SUBDIVISION COMMITTEE
METROPOLITAN AREA PLANNING COMMISSION

STAFF REPORT
(Preliminary Plat)

CASE NUMBER: S/D 90-21 - OAK CLIFF ESTATES 5TH ADDITION

STAFF REPORT

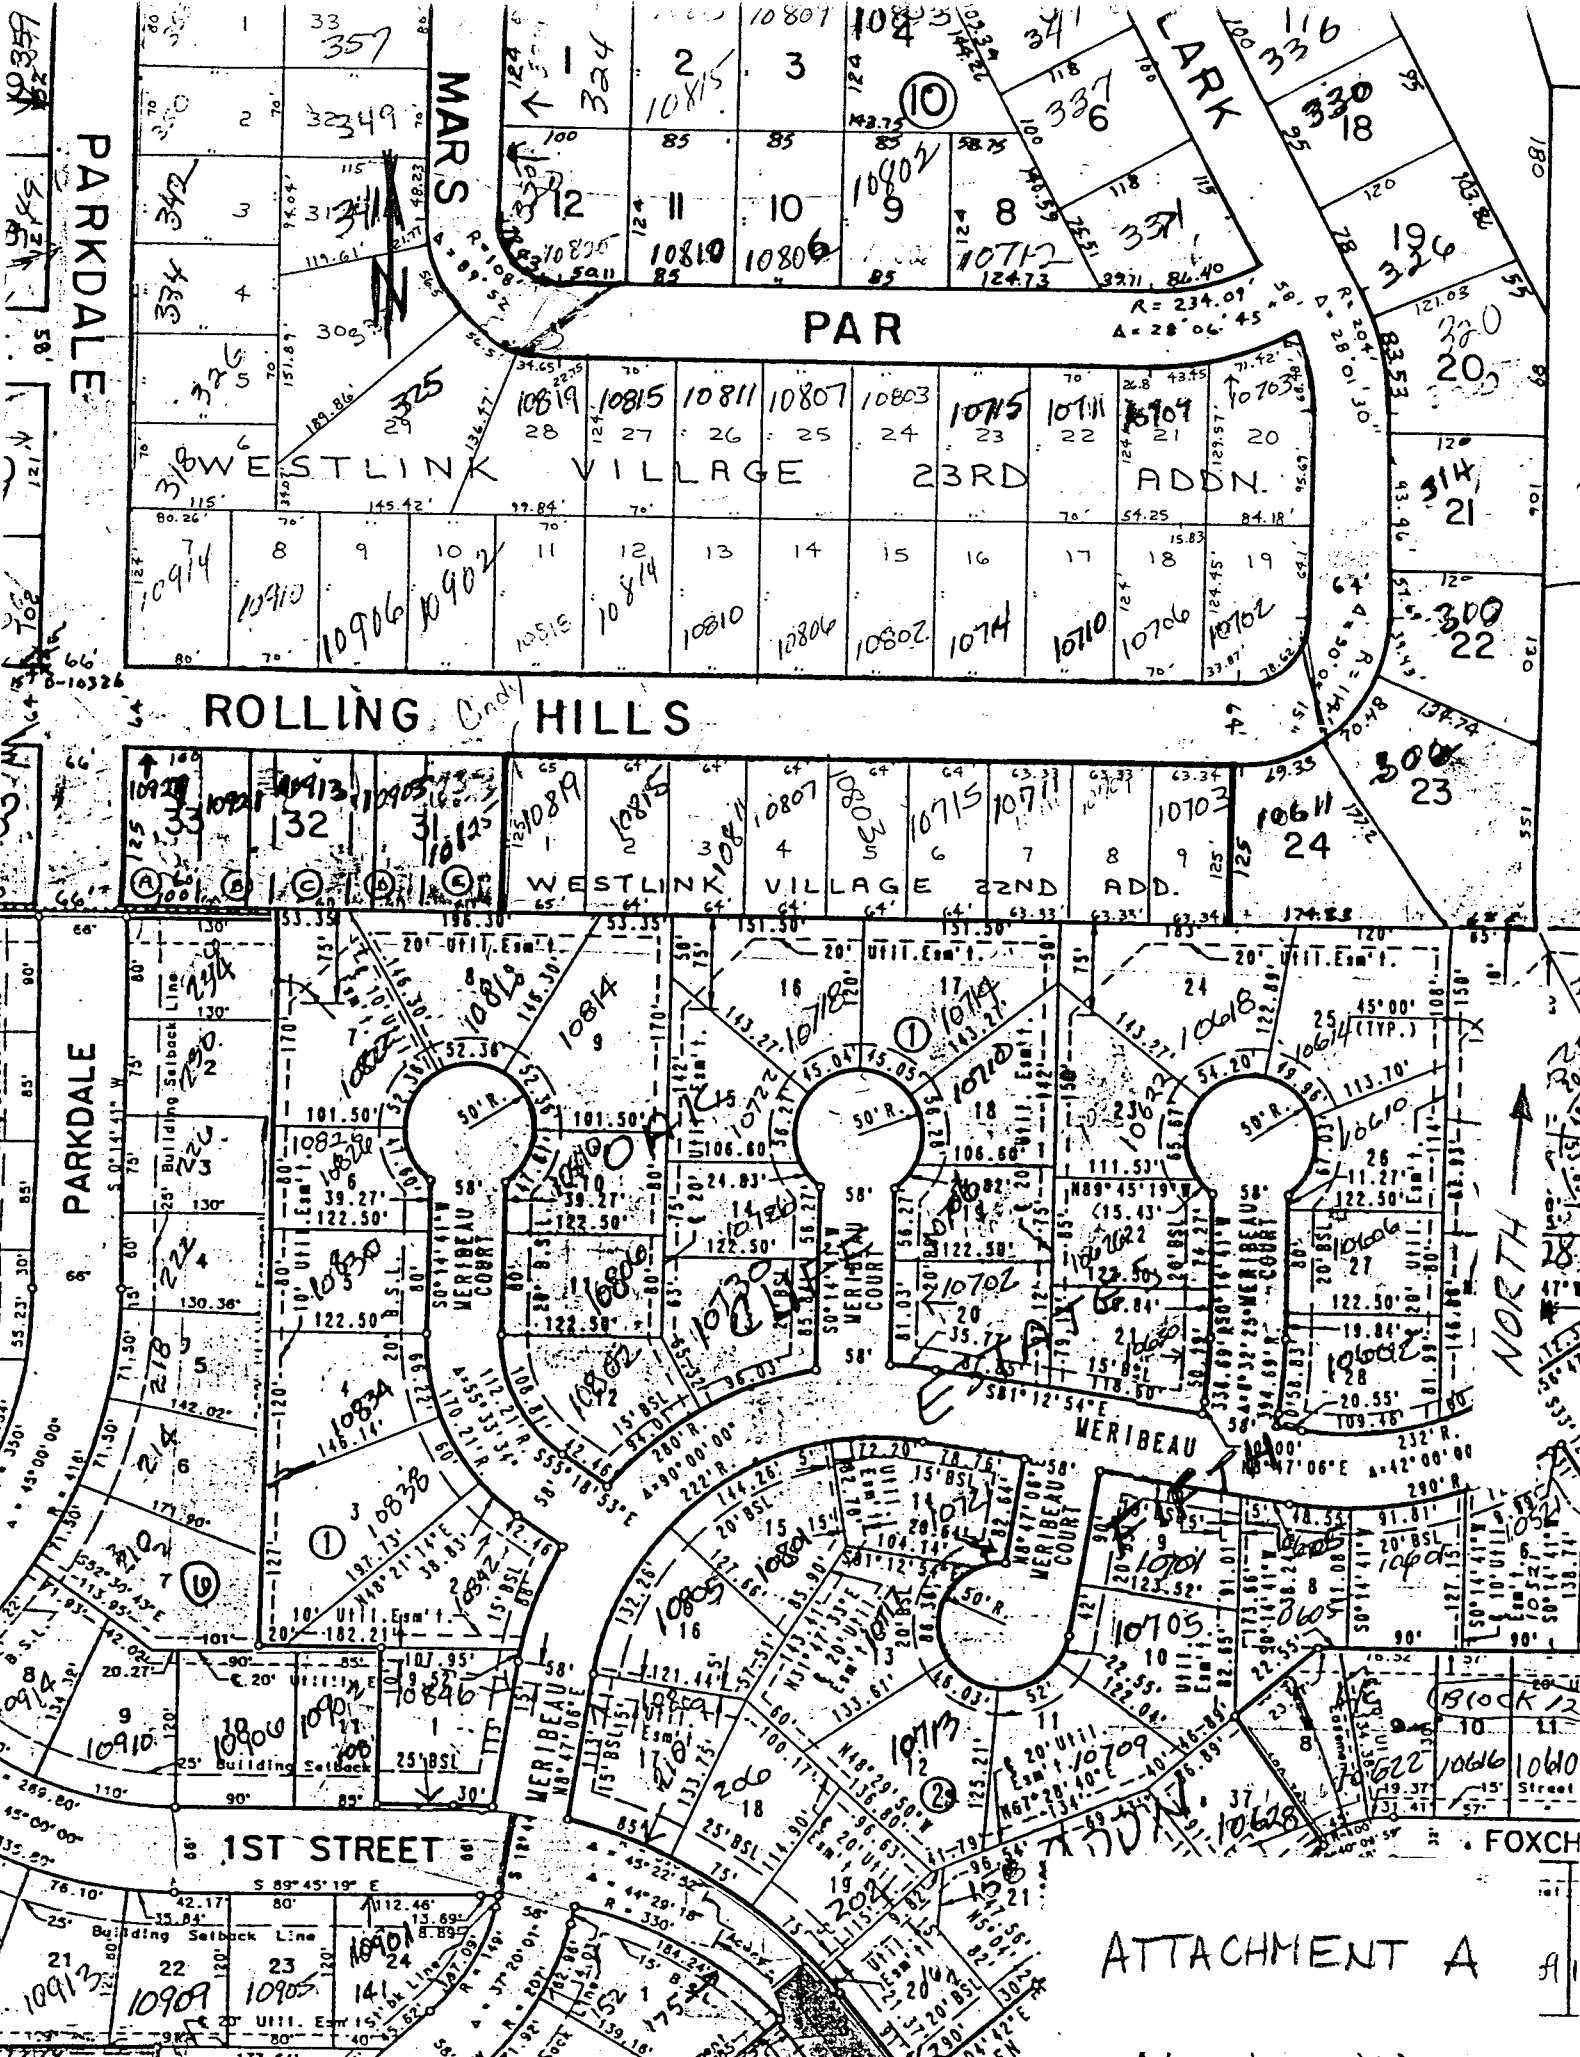
- A. This replat is resulting in substantial changes in the required improvements originally guaranteed with the Oak Cliff 3rd Addition. Consequently, existing petitions shall be abandoned and any associated costs paid off. New guarantees shall be provided for the extension of water and sanitary sewer, drainage improvements and street paving improvements.

- F. As requested by the Office of Central Inspection, the final plat tracing shall use the street name, Karren Ct. instead of Mars Circ. for the cul-de-sac in Block 2 by lots 20 thru 25.

- J. Perimeter closure computations shall be submitted with the final plat tracing. Section 5-101(c).
- K. Recording of the plat within 30 days after approval by the City Council.

- L. The representative from City Engineering should be prepared to comment on the status of the applicant's drainage plan and if the minimum building pad elevations are acceptable.

ATTACHMENT D

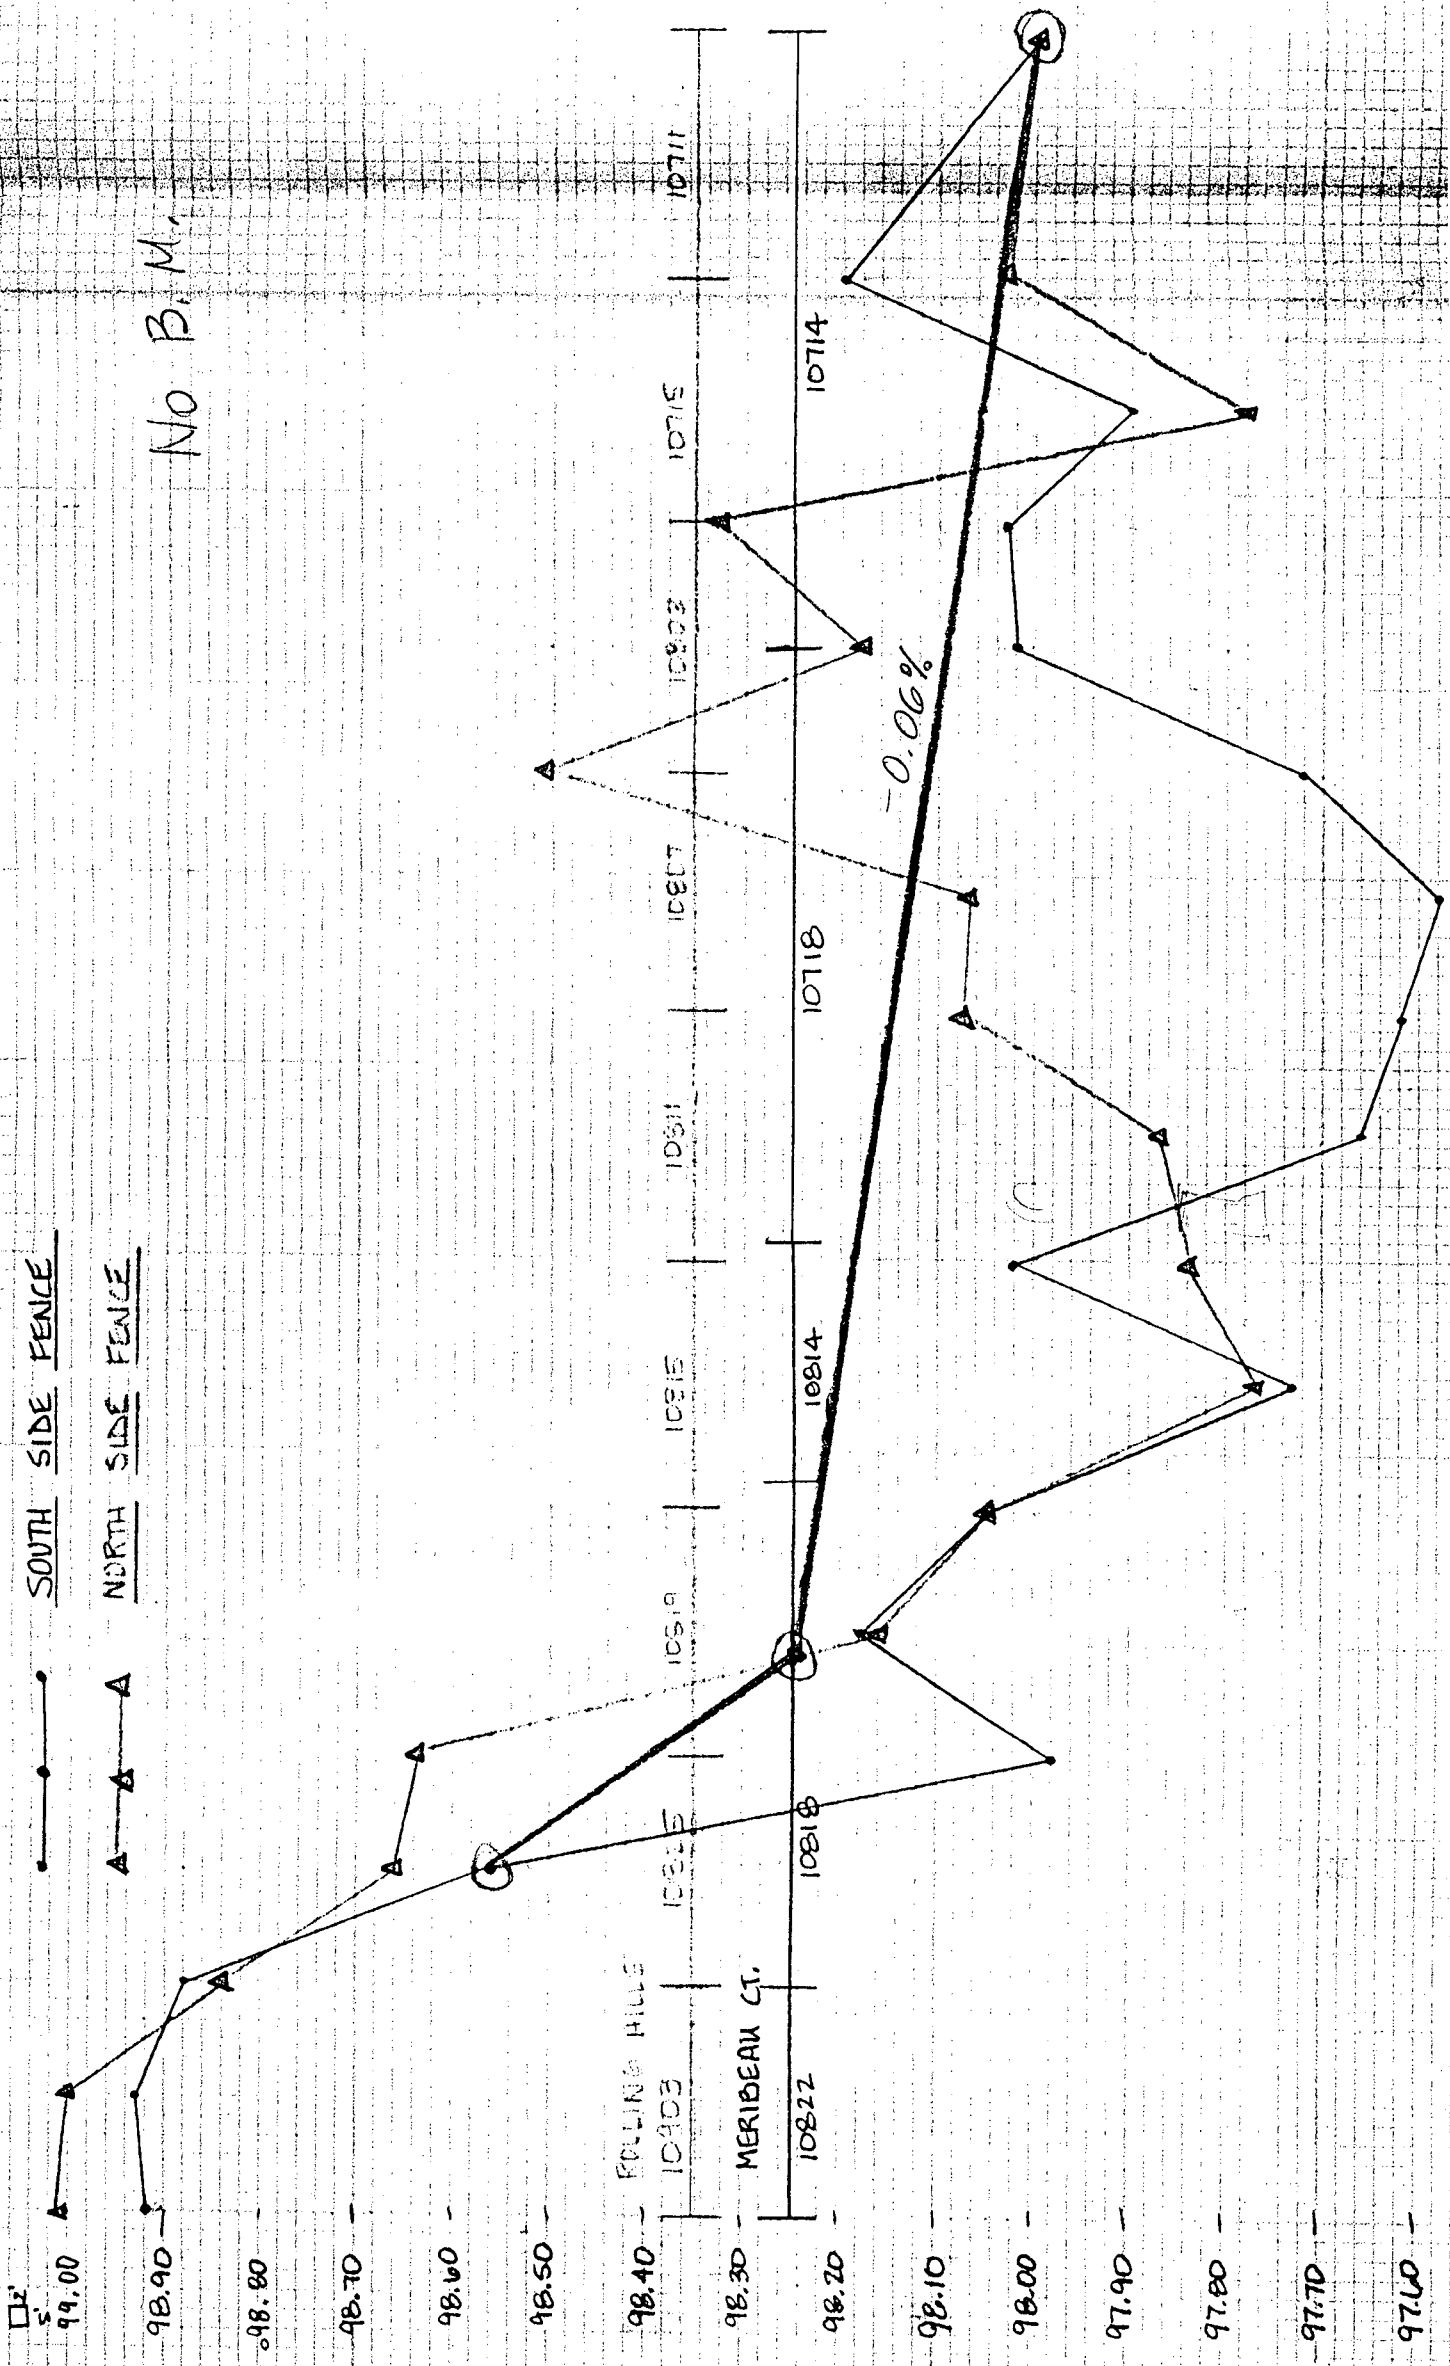
No B.M.
